**SUBJECT:** Savannah River Site's Responses to the Regulatory Comments on the Biennial Effectiveness Monitoring Report (EMR) for Monitored Natural Attenuation (MNA) at the C-Area Burning/Rubble Pit (131-C) and Old C-Area Burning/Rubble Pit (NBN) Operable Unit (U) January 2021 through December 2022 (SRNS-RP-2023-00648, Revision 0, June 2023) SEMS Number: 31

**SRS Responses to USEPA Comments on the Biennial Effectiveness Monitoring Report (EMR) for Monitored Natural Attenuation (MNA) at the C-Area Burning/Rubble Pit (131-C) and Old C-Area Burning/Rubble Pit (NBN) Operable Unit (U), January 2021 through December 2022, SEMS Number: 31, SRNS-RP-2023-00648, Revision 0, June 2023**

**SRS Responses to SCDHEC Comments on the Biennial Effectiveness Monitoring Report (EMR) for Monitored Natural Attenuation (MNA) at the C-Area Burning/Rubble Pit (131-C) and Old C-Area Burning/Rubble Pit (NBN) Operable Unit (U), January 2021 through December 2022, SEMS Number: 31, SRNS-RP-2023-00648, Revision 0, June 2023**

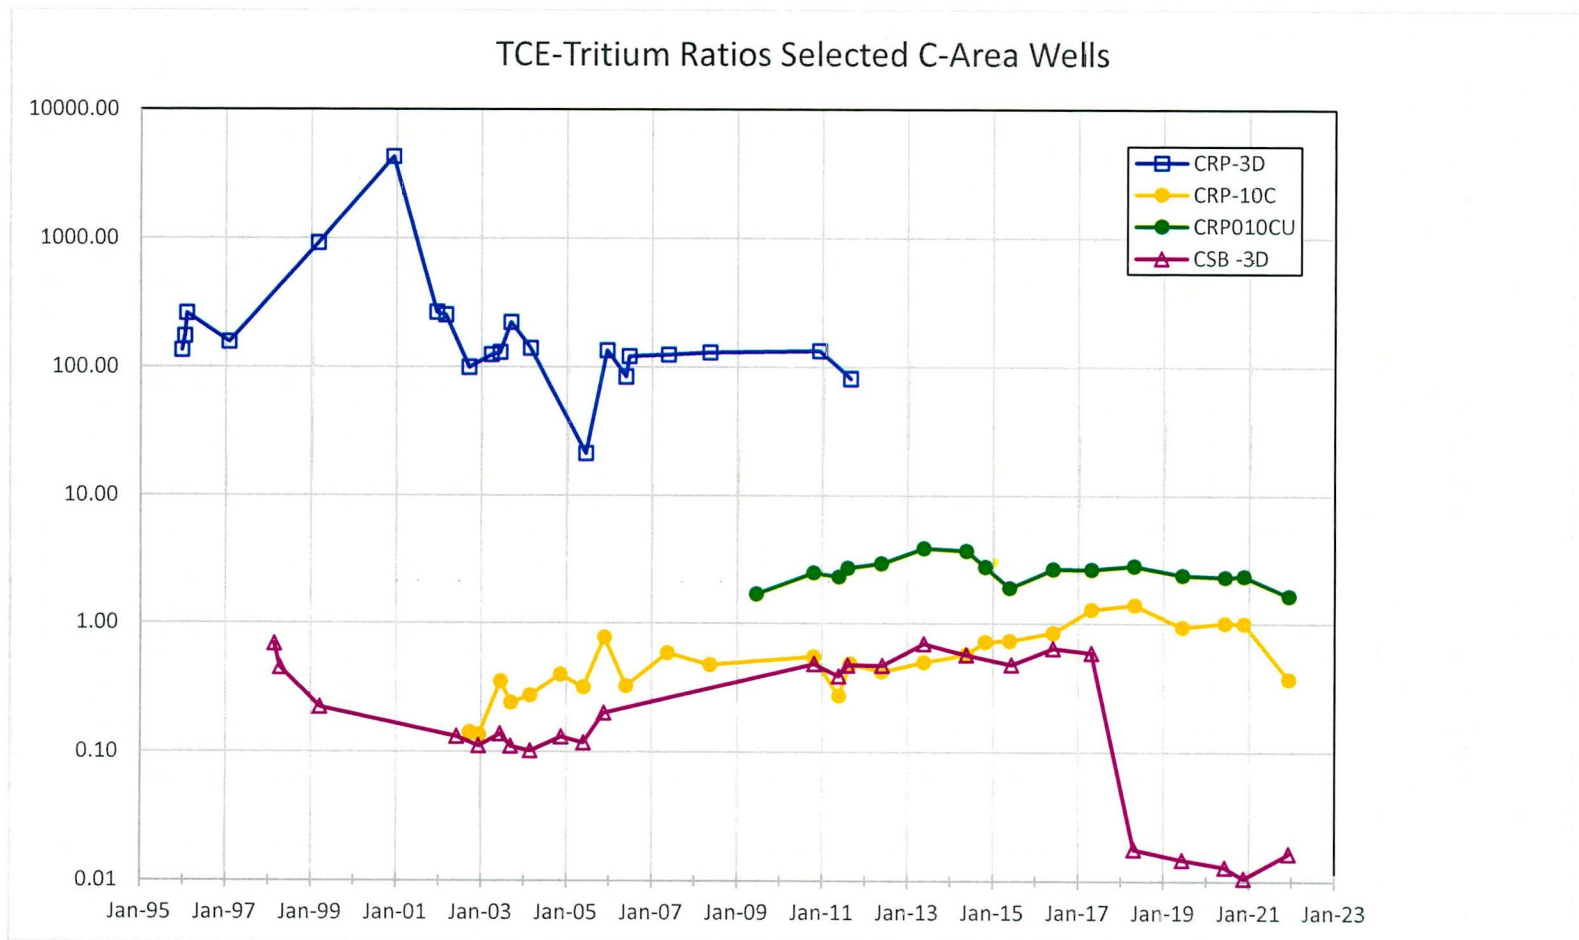
8. **Appendix E, Figure E-5, 2022 TCE Results for the Gordon Aquifer (GA), Page E-7:** It appears Figure E-5 is mis-named. The figure title for E-5 is “2022 TCE Results for the Gordon Aquifer (GA);” however, the figure presents potentiometric contours for the GA. Please revise the figure title to address the discrepancy.

**Response:** Agree.

**SRS will ensure all figure titles correctly correspond to the figures in future CBRP OU EMRs. No changes are proposed to the current report.**

**TCE – Tritium Ratios for Selected C Area Wells**

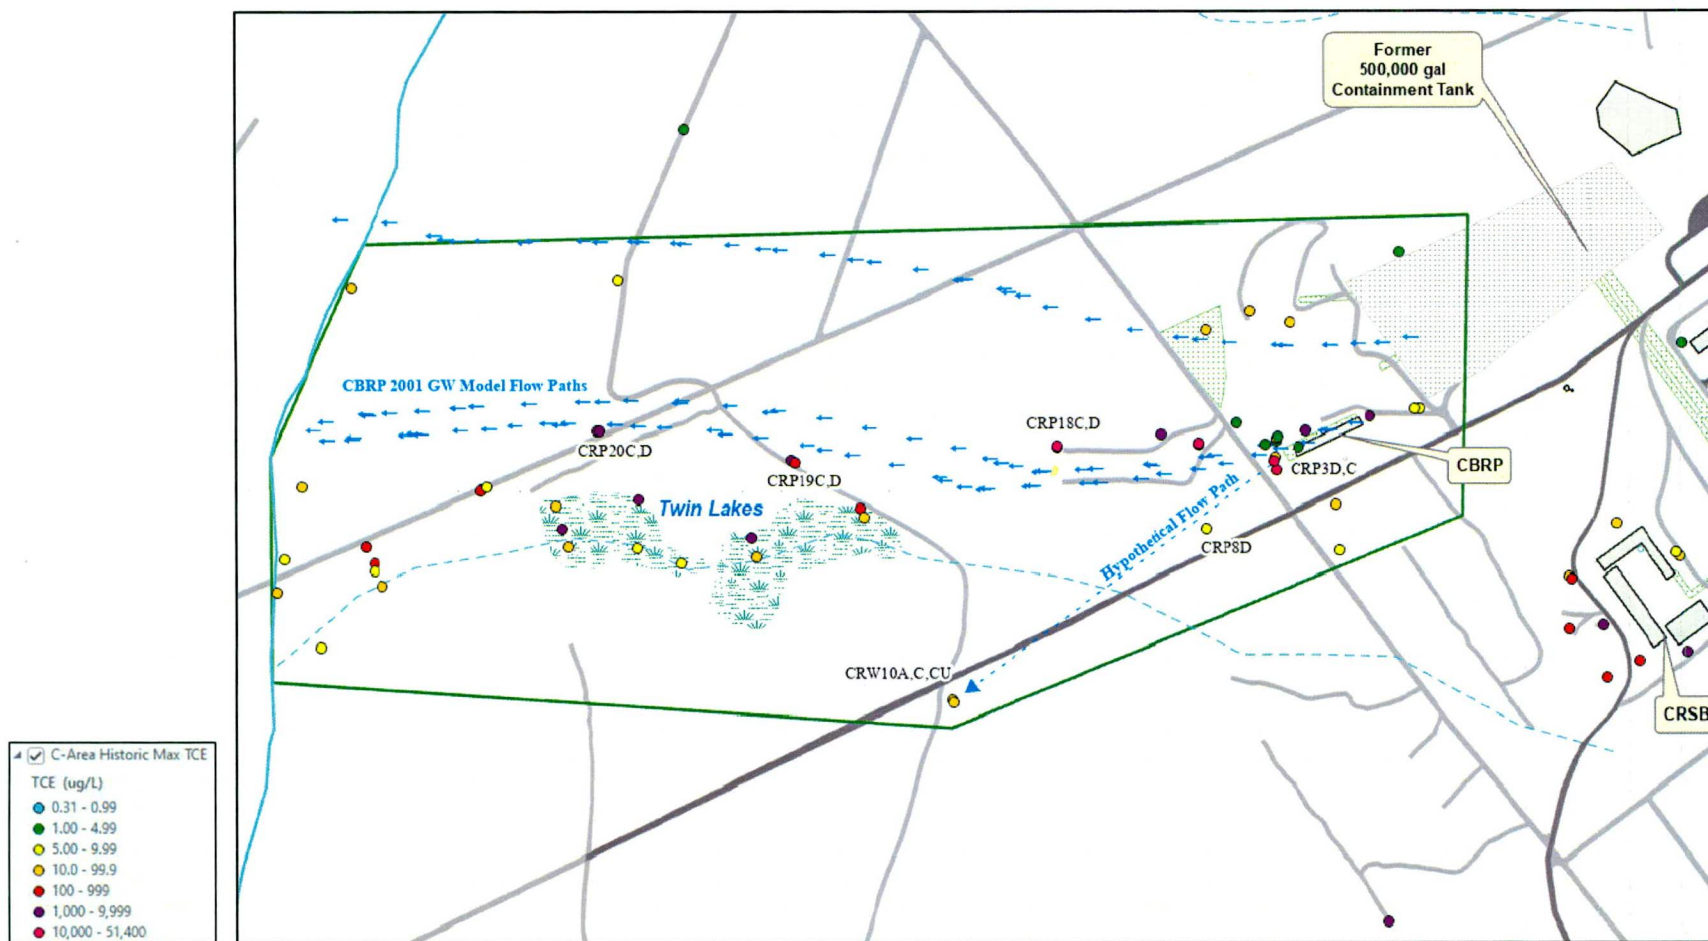
1. It is unclear whether the wells recommended for replacement of CRW 010 well cluster (i.e., CRW10CU, CRW10C and CRW 10A) are sufficient to monitor the southwest boundary of the C-Area Burning/Rubble Pit (CBRP). The text recommends removal of CRW 010 from the sampling program, as contamination observed in this well is likely from the C-Area Groundwater (CAGW) Operable Unit (OU), instead of the CBRP plume. The EMR recommends monitoring wells CRP 6DR and CRP 8D as replacement wells to delineate the plume; however, these two wells are located east of CRW 010 and north of the intermittent stream and are not sufficient to delineate and monitor the southwestern behavior of the plume. In order to remove CRW 010 from the monitoring plan, a new southwestern boundary well should be recommended to address the data gap, as the southern boundary of the trichloroethylene (TCE) plume in the Upper Aquifer Zone and Middle/Lower Aquifer Zone is currently not defined (see Appendix D, Figure D-3, 2022 TCE Concentrations in the Upper Aquifer Zone of the Upper Three Runs Aquifer, and D-4, 2022 TCE Concentrations in the Middle/Lower Aquifer Zone of the Upper Three Runs Aquifer). Please revise the text to recommend an additional well in the southwest as a replacement of CRW 010 boundary well cluster.

Well CDB 3D, which is the nearest downgradient well to the CBRP OU pit has high TCE concentrations and low tritium concentrations, which yield high TCE to tritium ratios in the groundwater. In contrast, wells CRW 10C and CRW010CU have higher tritium concentrations relative to TCE, which yield low TCE to tritium ratios (Attached Figure of TCE-Tritium Ratios Select C-Area Wells). The low TCE to tritium ratios in the CRW 10 well cluster are indicative of a CAGW OU source because tritium contamination in

CBRP OU Average TCE Trend (Based on all monitoring stations 2000-2022)

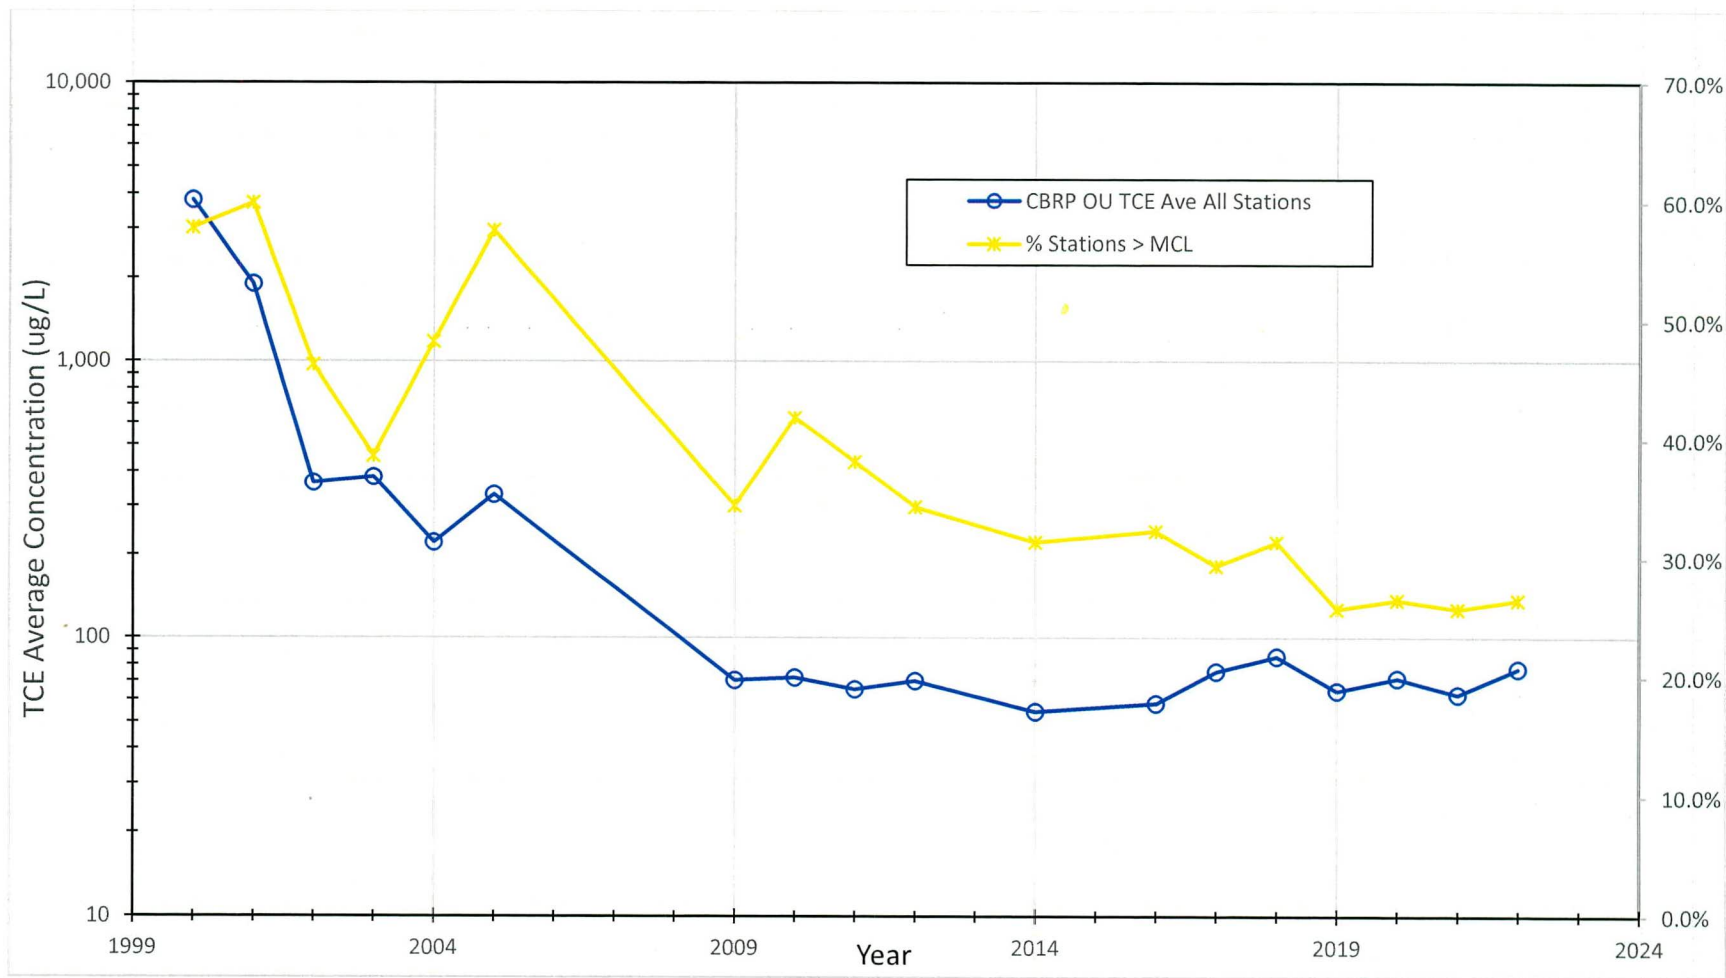
- 4. Section 5, Summary, Page 18:** It is unclear whether the figures in Appendix C support the statement that concentrations of TCE continue to decrease overtime. Many of the time series plots depict relatively stable TCE concentrations trends for wells exhibiting detections (including CRW010, CRP 50, CRP 46, CRP 45B, CRP 20CU, CRP 18C, and CRP 48B and CRP 22 since 2010), and the majority of remaining wells are consistently non-detects, but very few wells actually show significant decreases in concentrations. Please revise the statement in support of the trend graphs provided.

The long-term (2000-2022) average TCE concentration for all monitoring stations indicates a large decrease in the groundwater TCE concentration for the CBRP OU. The trend has been relatively stable from 2009 to 2022 (see attached CBRP OU Average TCE Trend figure). The maximum concentration of the plume, currently centered on CRP 20CU, has the biggest impact to the average TCE plume concentration, but the percent of monitoring stations exceeding the MCL (5 ug/L) has decreased from about 42% (13 of 31 stations) to about 27% (9 of 34 stations) from 2010 to 2022. The decreasing number of stations where groundwater exceeds the MCL is another indication of a contracting plume. SRS proposes adding these two metrics to Section 4.6.1 in future CBRP OU EMRs. No changes are proposed to the current report.

**TCE – Tritium Ratios figure for Selected C Area Wells**

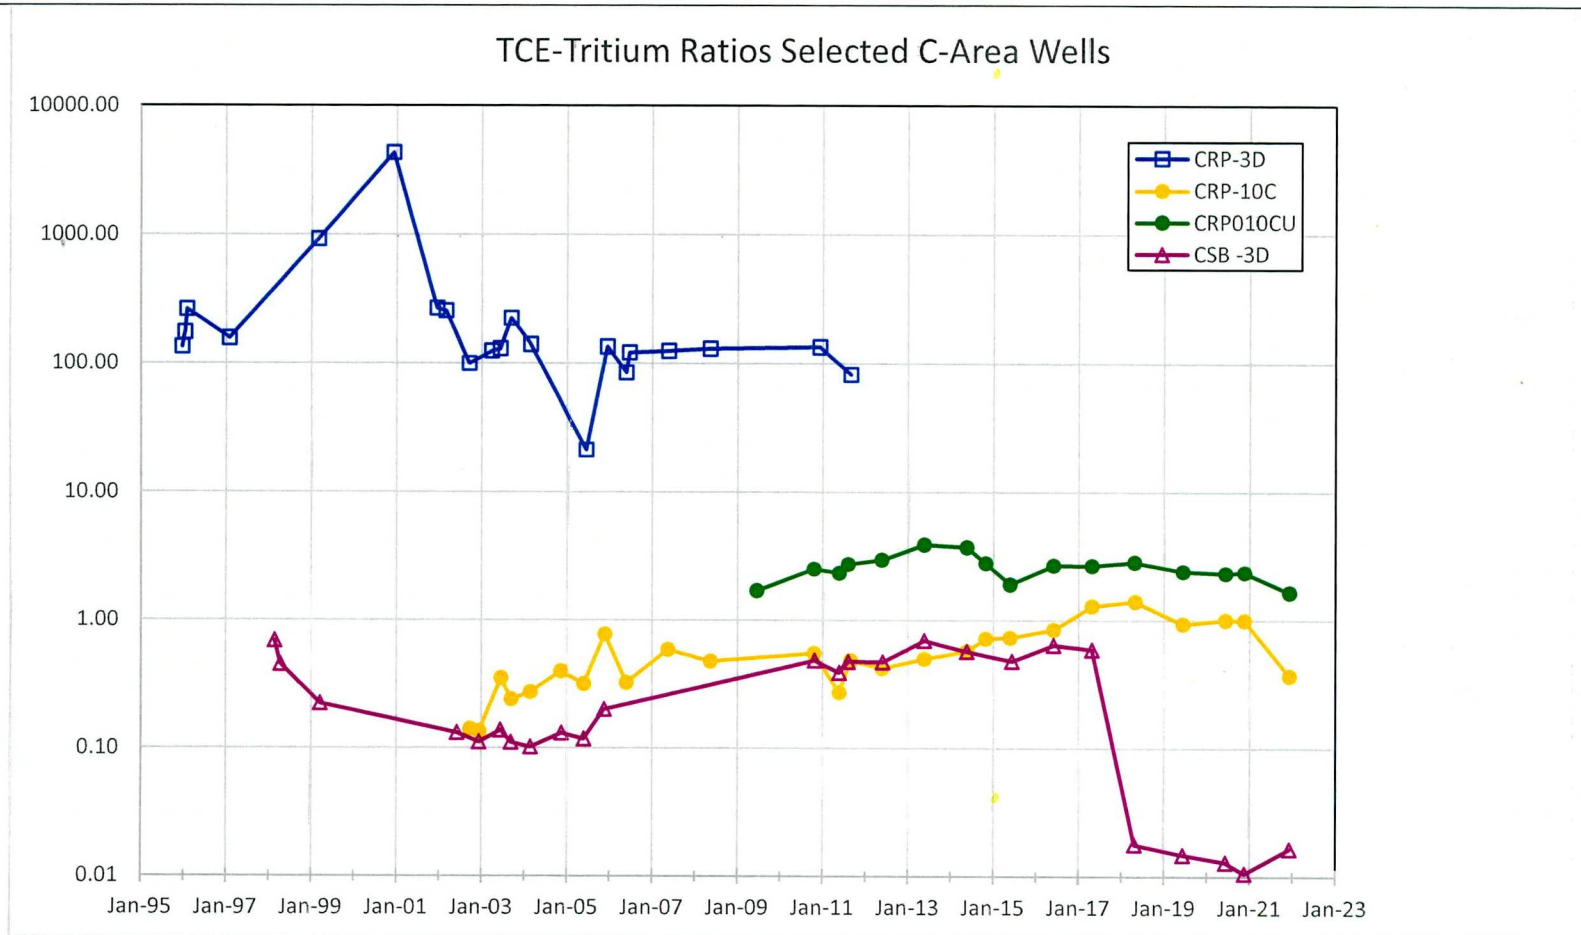
1. The Department does not agree with the recommendation to replace wells CRW010CU, CRW 10A, and CRW 10C with wells CRP 6DR and CRP 8D as LUC boundary wells. Due to the exceedance of a trigger level at well CRW010CU, the Department prefers that the Core Team be convened to discuss a path forward as per protocols mentioned in Section 4.4.

Well CDB 3D, which is the nearest downgradient well to the CBRP OU pit has high TCE concentrations and low tritium concentrations, which yield high TCE to tritium ratios in the groundwater. In contrast, wells CRW 10C and CRW010CU have higher tritium concentrations relative to TCE, which yield low TCE to tritium ratios (Attached Figure of TCE-Tritium Ratios Select C-Area Wells). The low TCE to tritium ratios in the CRW 10 well cluster are indicative of a CAGW OU source because tritium contamination in the groundwater is sourced from the C-Area Reactor and the C-Reactor Seepage Basins.
